Subject: *Centro de Gestión de Residuos Sólidos en el Bordo Poniente: Feedback Regarding Aeroméxico's Takeoff Performance Analysis*

The objective of this document is to provide you with MITRE's feedback and opinion regarding the results of Aeroméxico's takeoff performance analysis.

Figure B-1. Distances from NAICM Runways to Proposed Facility Locations

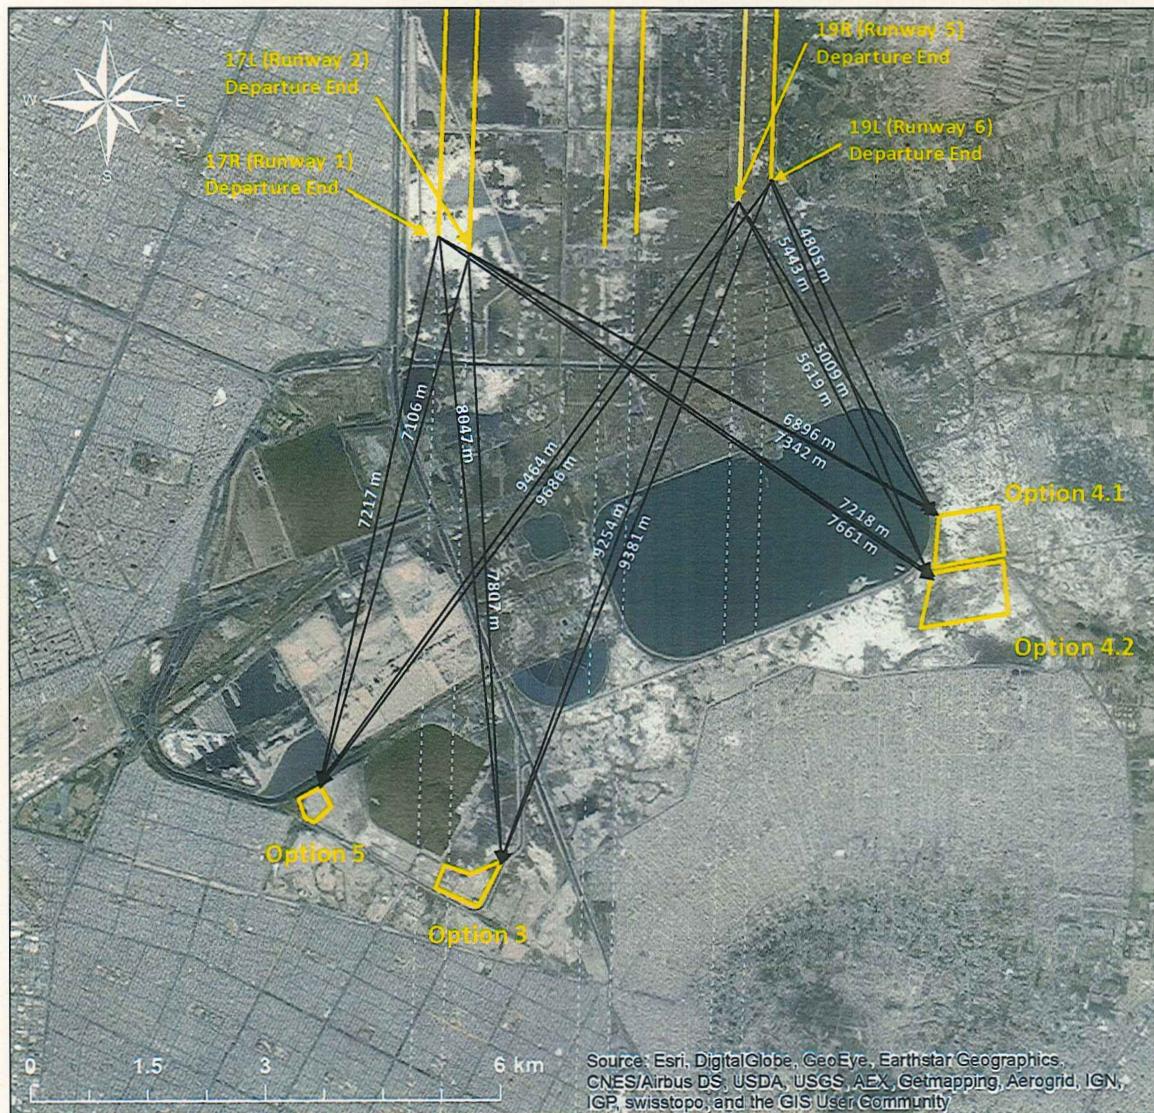
Based on the data provided by Aeroméxico in Appendix A (see the part of the table titled “NUEVO AICM”), none of the proposed facility locations depicted in Appendix B affect takeoff performance at NAICM.

As an example, the largest distance in Appendix A for the NAICM runways examined is 5200 m, which applies to a turning takeoff procedure from Runway 17R for a Boeing B787-8 and a Boeing B737-800. Note from Appendix B that all proposed facility locations potentially affecting Runway 17R takeoffs are more than 7000 m from Runway 17R. Therefore, an aircraft conducting a turning takeoff procedure would be higher than the 2275 m MSL smokestack at 5200 m from the departure end of Runway 17R by the time it reaches any of the proposed facility locations.

As a second example, the closest distance from the departure end of Runway 19L to Option 4.1 is 4805 m, as shown in Appendix B. However, as can be seen in Appendix A, the

largest distance for 19L is 4700 m, which applies to a turning takeoff procedure for a Boeing B787-8. Therefore, an aircraft utilizing Runway 19L will exceed the 2275 m MSL smokestack height before reaching Option 4.1.

An inspection of the required distances from each runway end to clear a 2275-m obstacle shows that in every case the measured distance from runway end to facility location is greater than the required distance.

Figure C-1. Distances from AICM Runways to Proposed Facility Locations

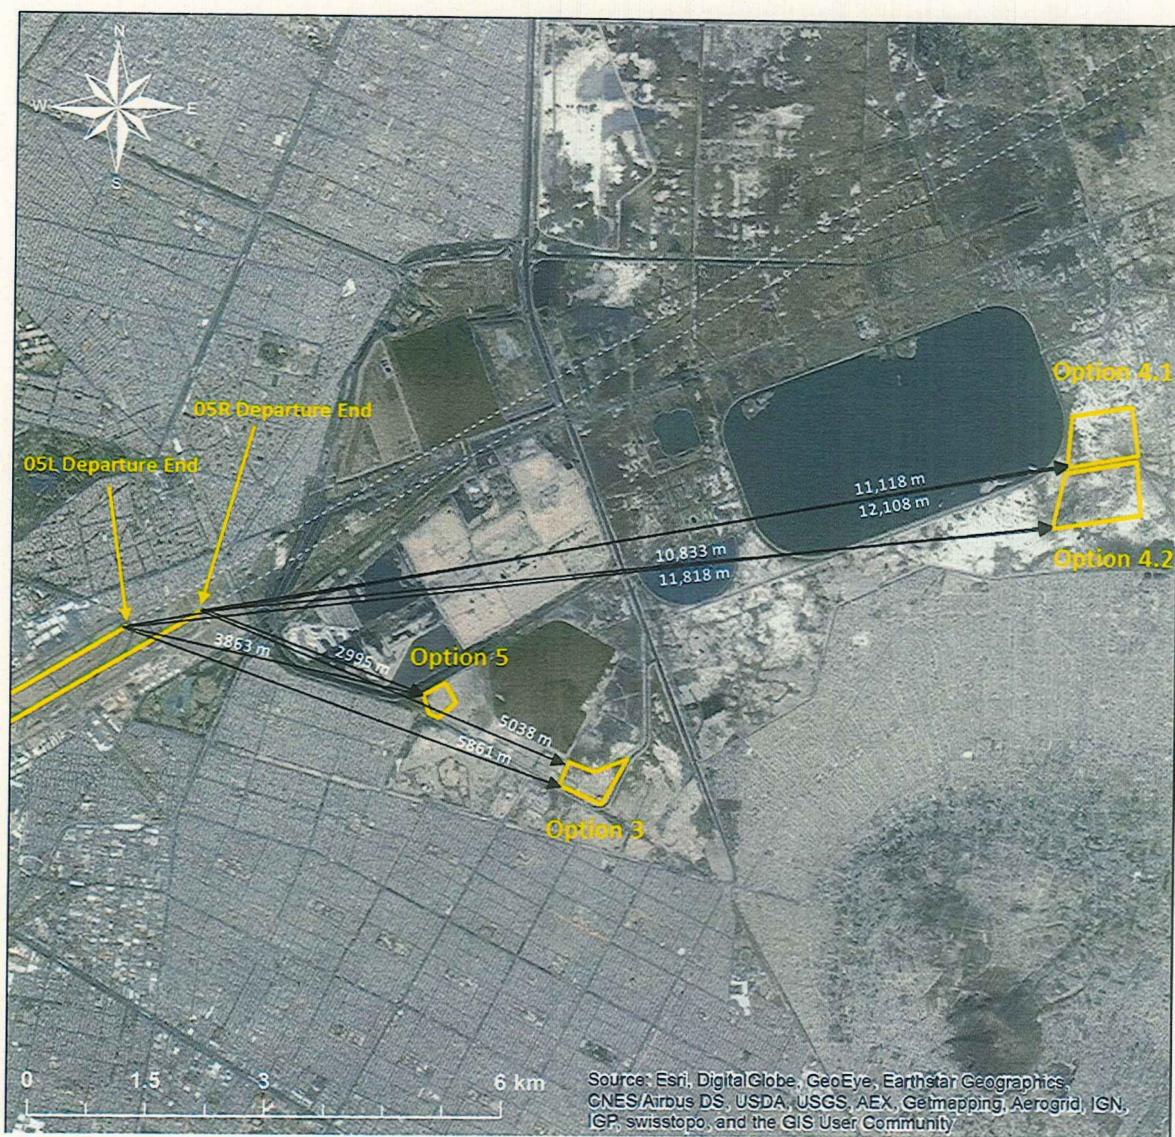
Based on the data provided by Aeroméxico in Appendix A (see the part of the table titled “MEX”), none of the proposed facility locations depicted in Appendix C, except for Option 5, affect takeoff performance at AICM.

Note from the table in Appendix A that the largest distance is 4850 m, which applies to a turning takeoff procedure from Runway 05L for a Boeing B737-800. All proposed facility locations, except for Option 5, are farther than 4850 m from the departure end of either Runway 05L or Runway 05R at AICM, as shown in Appendix C. Thus, an aircraft taking off from AICM would exceed the obstacle height of 2275 m MSL no later than 4850 m from either runway at AICM.

Option 5 is the only proposed facility location that poses a potential problem for a takeoff procedure from AICM. However, note from Appendix C that the Option 5 location is approximately 45° to the right of the Runway 05L and Runway 05R centerlines. Thus, if Option 5 should be seriously considered, it is important that the airlines and SENEAM ensure whether a hard-right turn toward Option 5 is preventable. If so, Option 5 would not pose a difficulty for takeoff procedures from AICM.
